APPENDIX A – SUBMISSIONS REGISTER

1. CITY OF PARRAMATTA COUNCIL

Table 1 Council Comments

Figure 1 Public Domain Concept

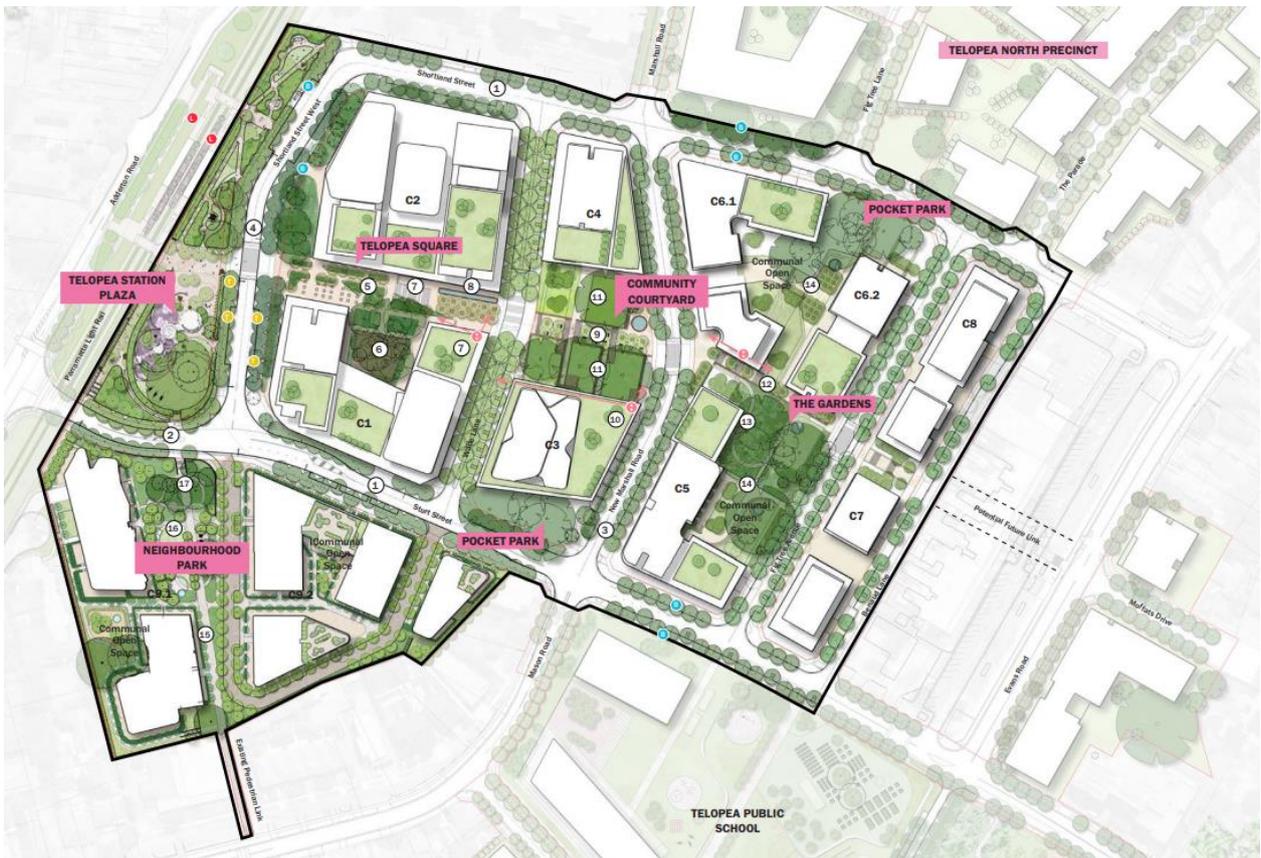
<p>Public domain improvements directly adjacent to development sites should be included as Conditions of Consent of any approval and not be part of local contributions or the VPA.</p>	<p>This is not agreed to by the Proponent. The proposed public domain improvements are considered well above the average streetscape expectations for a residential development. Overall, the streets have been designed to have noticeable public benefits and are vital to the overall public</p>	<p>Appendix E</p>

Council Comment	Response	Supporting Documentation (RTS Report Section/ Appendix)
	<p>domain strategy for the CPA (refer to Appendix E). Public domain improvements include street furniture, public art installations, cycle ways and generous street tree planting for connected canopies and shade.</p>
